NCC Volume One NCC Public Comment Draft – Energy Efficiency

Response Sheet

Organisation: Housing Industry Association (HIA)

Clause/Figure/Table: J4D6, Specification 37

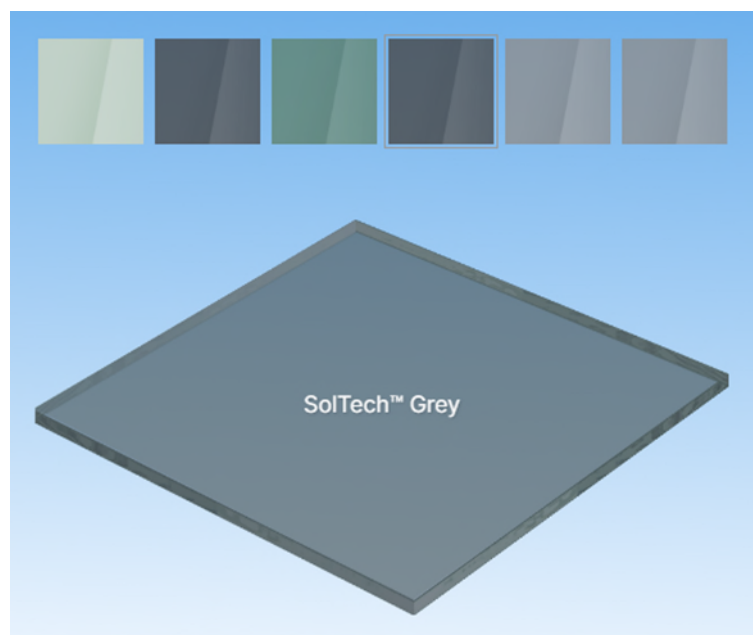
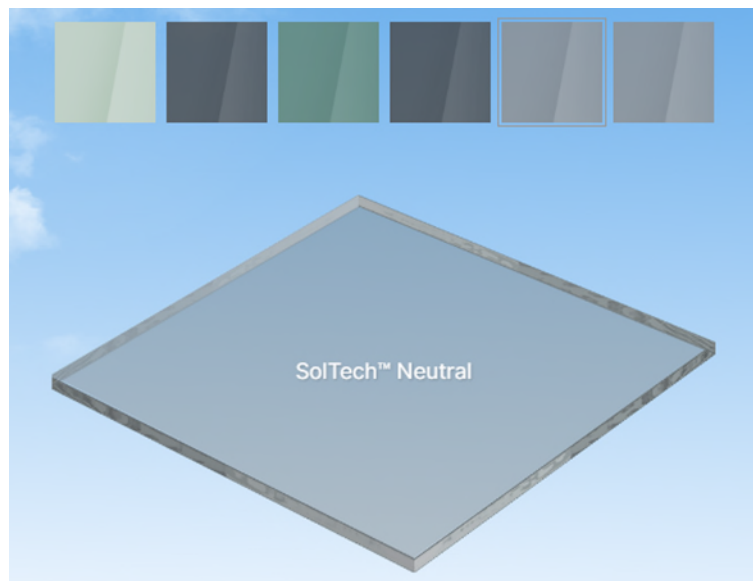
Revert to NCC 2022 targets; particularly for Class 3 and 9 buildings

These changes will result in exceedingly low SHGC figures for glazing in these buildings, even in heating dominant (cold winter CZ 8 and 7) and mixed climate zones (e.g. CZ 6), where solar heat gain is vital in winter to offset heating loads. SHGC of as low as 0.3 has been determined in some example buildings, which also raises questions around supply

chain capacity to deliver. HIA hold concerns this is an outcome. A solar admittance of 0.04 for a disability accommodation, and aged care in the northern aspect in CZ 8 would significantly affect occupant amenity in winter.

If this is being driven by future climate assumptions, the changes may be sacrificing heating/cooling load changes in the short term and not deliver expected savings under other equally likely scenarios. These building types often serve host to people with higher amenity needs (disabled and aged care facilities fall within Class 3 and 9).

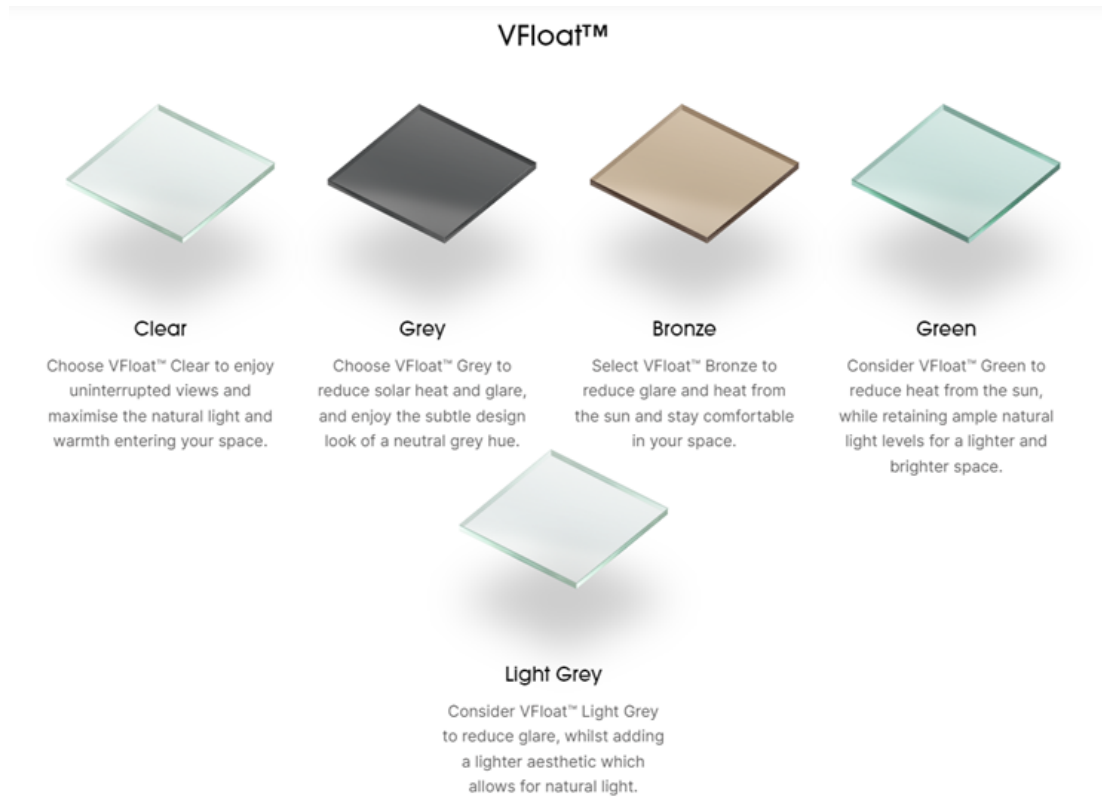
To highlight the difference in glazing required, the following from the Viridian Glass website:

- SolTech™ Neutral (SHGC 0.53) vs Soltech™ Grey (SHGC 0.37)

- Lightbridge double glazing using VFloat glass: VFloat Grey 6mm in the outer pane is required to achieve SHGC 0.32. Light grey will achieve SHGC 0.42. Substantial difference in glazing darkness
